Model Error Resolution Document

1. Originator: Jerry McNeish	2. Date: April 16, 2008	3. ERD No. MDL-WIS-PA-000005 ERD 02
4. Document Identifier: MDL-WIS-PA-000005 REV 00; and AD 01		5. Document Title: Total System Performance Assessment Model/Analysis for the License Application

This Error Resolution Document (ERD) is provided to update the TSPA-LA AMR Rev 00, and AD01 to correct issues identified in the following condition reports (CRs). There is no impact to the overall conclusion of the AMR caused by these minor corrections.

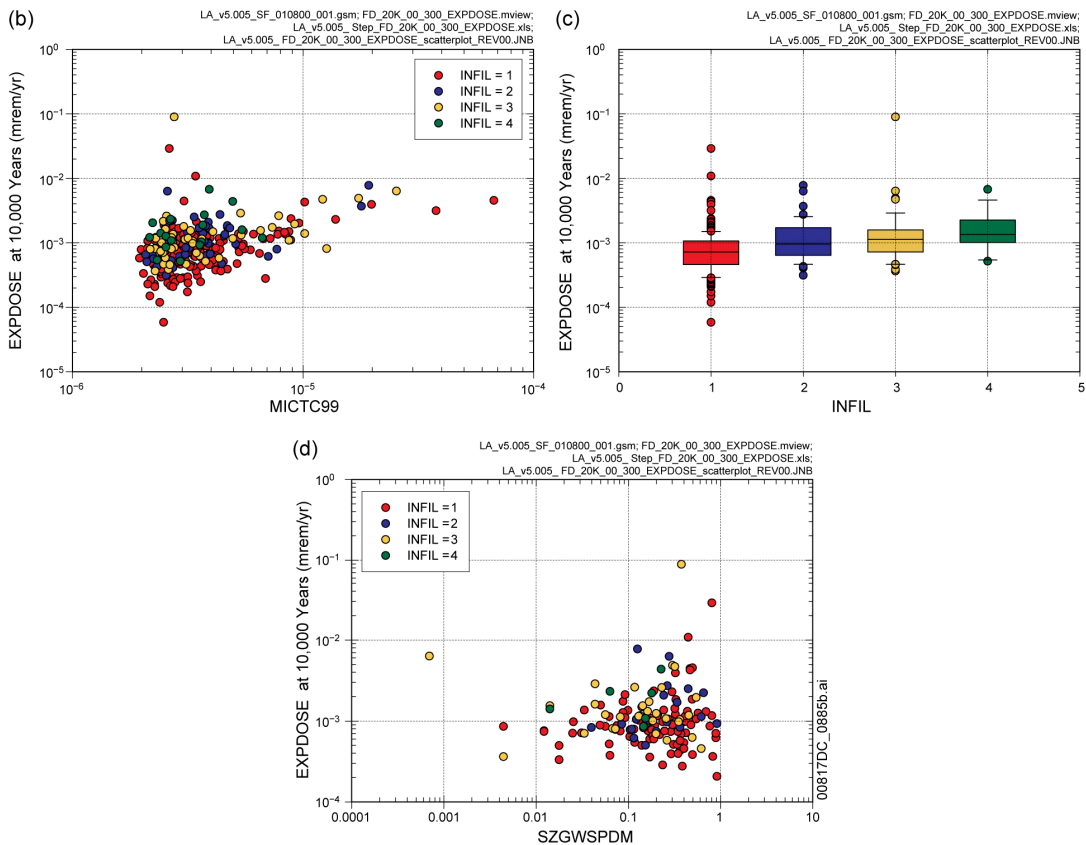
CR 11885—Incorrect information in Appendix K. The three scatterplots at the bottom of Figure K7.8.2-2[a] (00817DC_0882a) are repeats of the scatterplots in Figure K7.8.1-2[a] (00817DC_0885a) rather than the intended scatterplots. The figure needs to be updated with the correct scatterplots. The corrected figure (K7.8.2-2[a]) is provided in Attachment 2 to this ERD. Figure K7.8.1-2[a] is also included in Attachment 2 to correct a minor formatting error on the y-axis of scatterplot (b).

Figure 7.3.2-15[a]. Spatially Averaged Waste Package Outer Barrier Thickness for 1 Million Years for (a) CSNF Waste Packages and (b) CDSP Waste Packages

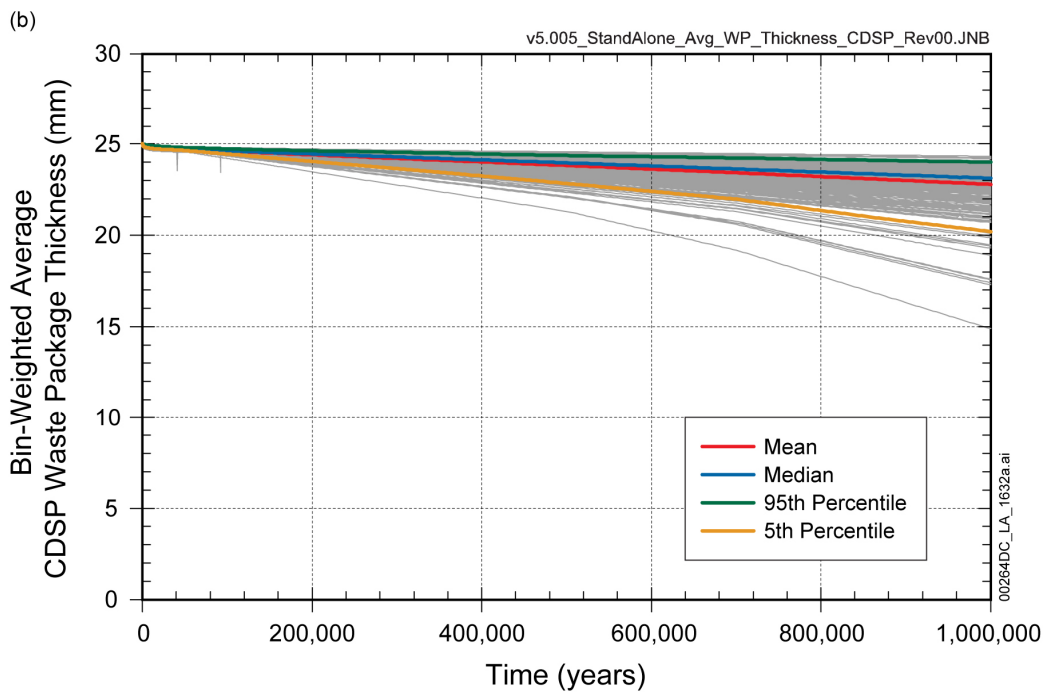
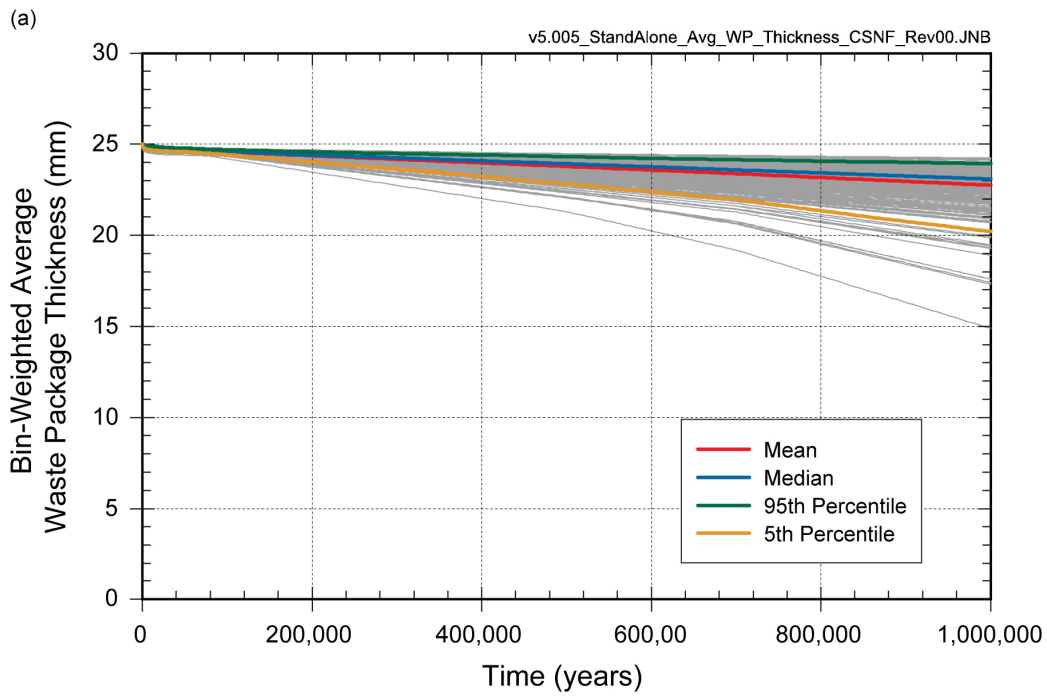
CR 11909—Supplemental Plots. AMR MDL-WIS-PA-000005, Rev. 00, TSPA-LA and Addendum 01 did not provide plots for data found in DTN: MO0801TSPAWPDS.000 and MO0710ADTSPAWO.000 related to the "Fraction of Drift Filled with Rubble", and the "Spatially Averaged Waste Package Outer Barrier Thicknesses for 1 Million Years for (a) Commercial SNF Waste Packages and (b) Codisposal Waste Packages." A new output DTN (MO0803TSPAPSAR.000 [DIRS 185276])

provides the plots generated from the two noted DTNs. This issue is known by the authors of the SAR and the appropriate corrective actions are being incorporated during the development of the SAR. See Attachment 5 for the new figures.
